TO:	Dr. Cone, Superintendent of Schools, LVISD	FROM:	Catherine Blackler <i>Catherine Blackler</i> Senior Project Manager, AGCM
cc:	Belinda Raindl, LVISD		Michael Rogers, AGCM
RE:	La Vernia ISD – Bond 2023	DATE:	June 19, 2025
SUBJECT:	RFI 097	PR DATE:	April 30, 2025
PR COST:	\$ 84,982.00	CONTRACTOR:	Bartlett Cocke (RCO 20)

#097 CTE Unforeseen Subgrade Drainage Condition

Subject: CTE Addition - Unforeseen Subgrade "Drainage" Condition

GRADING PLAN -
HIGH SCHOOL
WEST
C4.01
PACKAGE 2

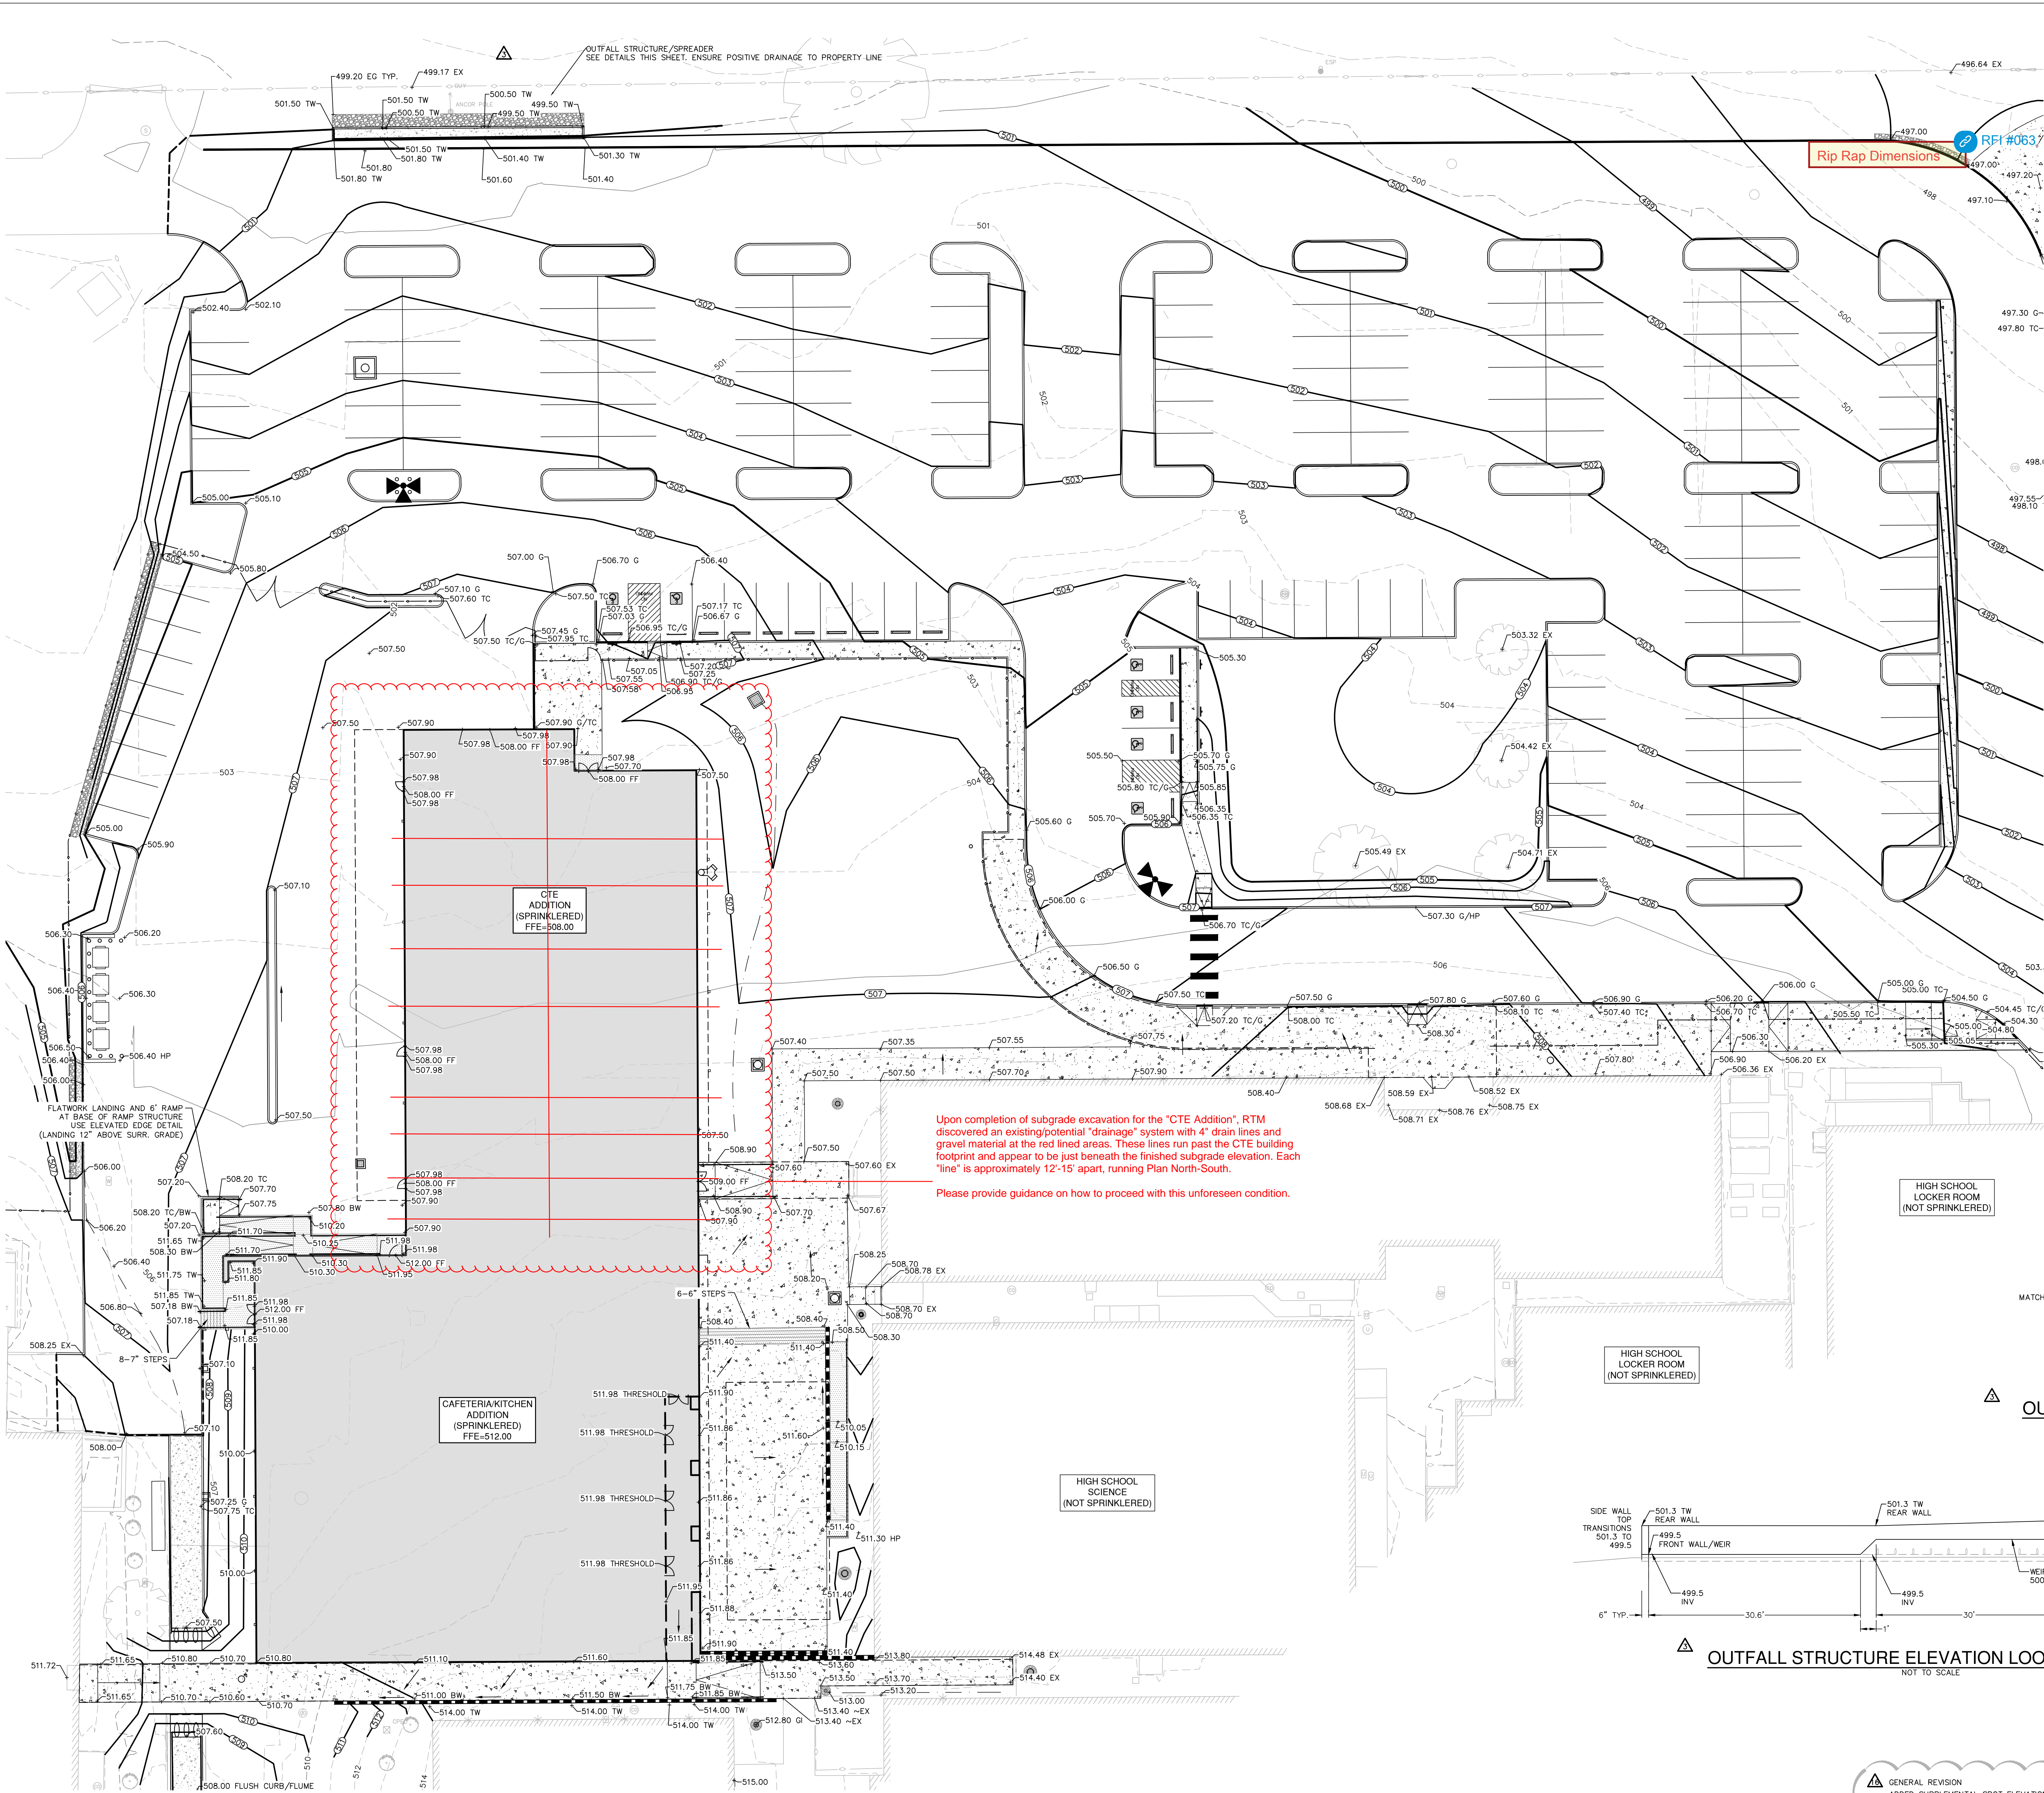
Upon completion of subgrade excavation for the "CTE Addition", RTM discovered an existing/potential "drainage" system with 4" drain lines and gravel material at the red lined areas. These lines run past the CTE building footprint and appear to be just beneath the finished subgrade elevation. Each "line" is approximately 12'-15' apart, running Plan North-South.

Upon completion of subgrade excavation for the "CTE Addition", RTM discovered an existing/potential "drainage" system with 4" drain lines and gravel material at the red lined areas. These lines run past the CTE building footprint and appear to be just beneath the finished subgrade elevation. Each "line" is approximately 12'-15' apart, running Plan North-South.

Please provide guidance on how to proceed with this unforeseen condition.

Thank you for providing the thickness of the gravel bedding. We recommend the gravel bedding be removed and replaced with select fill. Below is the section from the report which mentioned about the same.

Overcut building pad (150'x70') by 2' and replace with select fill material
